July 2019
FL780AB
NHTSA #18V-491
Transport Canada #2018-387
SECOND REVISED NOTICE

Subject: Cascadia ICUC Bulb Check Function

Models Affected: Specific Freightliner Cascadia vehicles manufactured May 3, 2016, through July 11, 2018, and equipped with a certain ICUC.

ICUC Software Update and Replacement of TPMS ECU

Fig. 5, TPMS Receiver

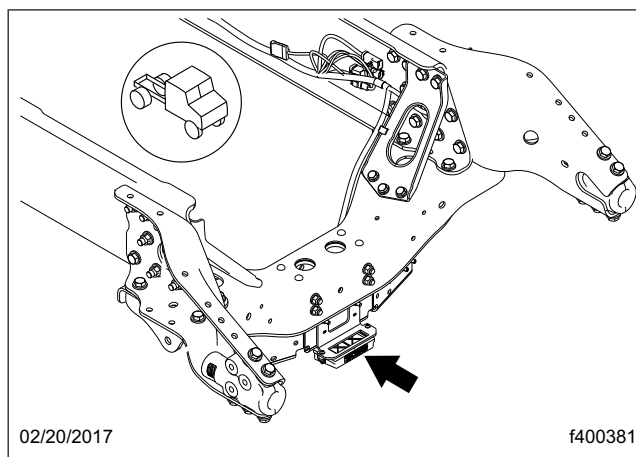
28. Disconnect the wiring harness and antenna cable from the TPMS ECU Receiver. See [Fig. 5](#).

29. Remove the two M6 x 1 flange-head capscrews and remove the TPMS ECU Receiver.
30. Use the existing bolt holes and the two M6 x 1 flange-head capscrews to attach the new TPMS ECU Receiver to the vehicle. Tighten the capscrews 7 to 10 lbf·in (79 to 158 N·cm).
31. With the ignition off, connect the wiring harness and antenna cable to the TPMS ECU Receiver.
32. Install the front bumper. Refer to Section 31.02, Subject 100 in the *New Cascadia Workshop Manual* for instructions.
33. Connect batteries and turn ignition on. Wait 10 seconds, then follow the DTNA_ECUSwap prompts and press OK. Continue to follow the prompts to transfer the configuration to the new TPMS ECU. When complete, the following message will display: "ECU Configuration has been successfully transferred."
